December 20, 2019

Mr. Jack Xu  
Santa Clara Valley Water District  
jxu@valleywater.org

**Subject: Los Gatos Creek Independent QC and Revisions to FINAL HEC-RAS model**

Figure 1: XS 2723 Downstream of Montgomery Road Culvert – Banks at Top

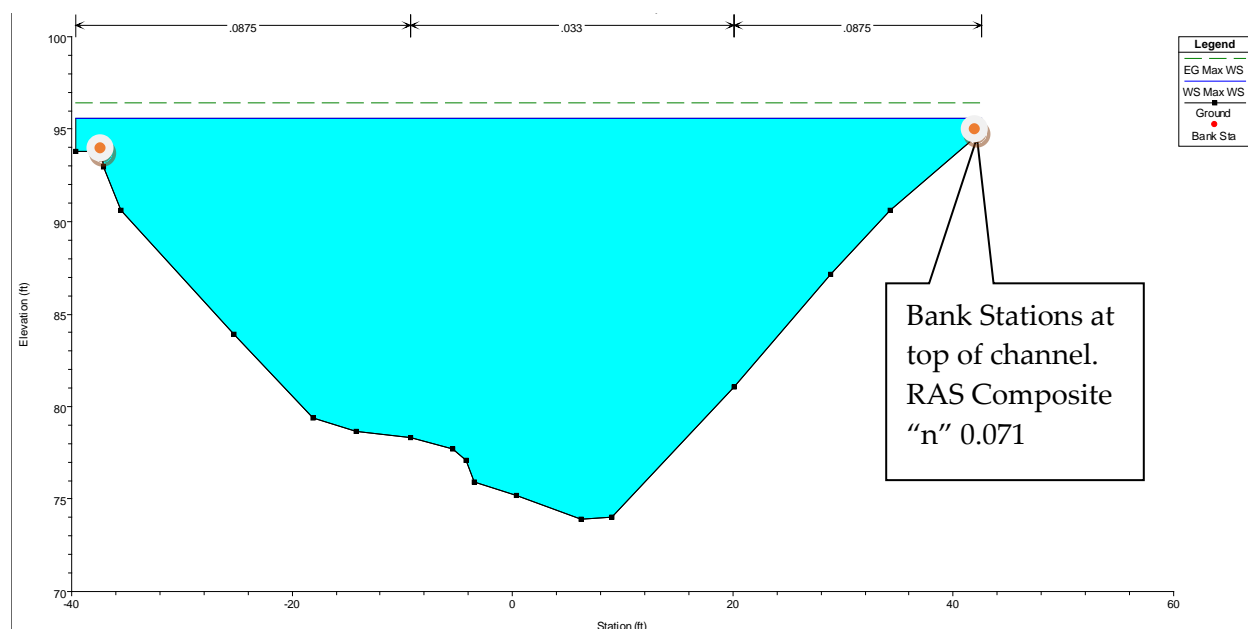
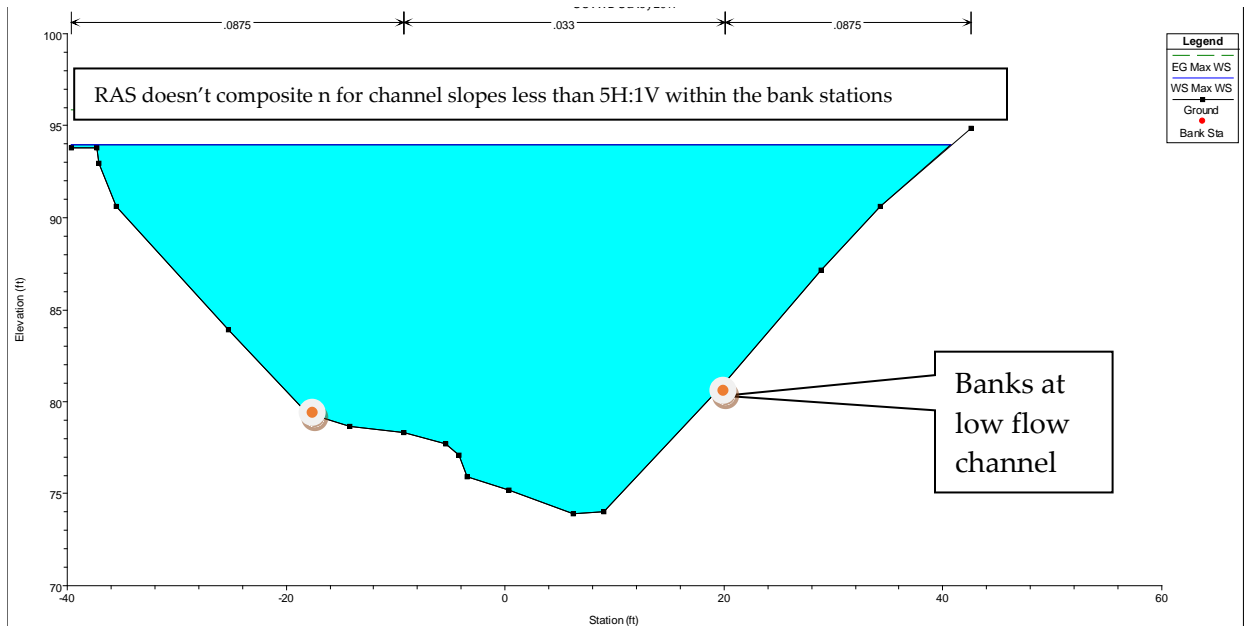
HEC-RAS defaults to compositing horizontally varied n-values for bank slopes greater than 5H:1V. Placing main channel bank stations at top of channel results in a high RAS composited n-value (example XS 5959 of 0.082 or XS 2723 of 0.071), which ranks at the high end of ten composite equations detailed in Appendix A. Note that RAS utilizes one of these ten equations which assumes each part of the cross sectional area has the same mean velocity and all are equal to the mean velocity of the whole section.<sup>1</sup> This assumption does not seem particularly valid with a widely varying roughness across the channel section. Placing bank stations at the top of the low flow channel calculates a low RAS composite Manning's "n". This results in high channel velocities generally above 10 ft/s and up to 16 ft/s<sup>2</sup>.

As the intent of the model is to run nearly bank full events, and banks at the low flow underestimate the influence of the vegetated slopes, banks at the top of the channel are considered to be the appropriate location. Additionally, the shape of the channel varies along the reach from Interstate 280 to the confluence but is generally trapezoidal with an incised low flow without prominent floodplain benches, which further supports placing model banks at the top of the channel. There is a significant difference in composite roughness when moving the model main channel bank stations from the low flow to the top of the channel with no other modifications as seen in Figures 1-4.
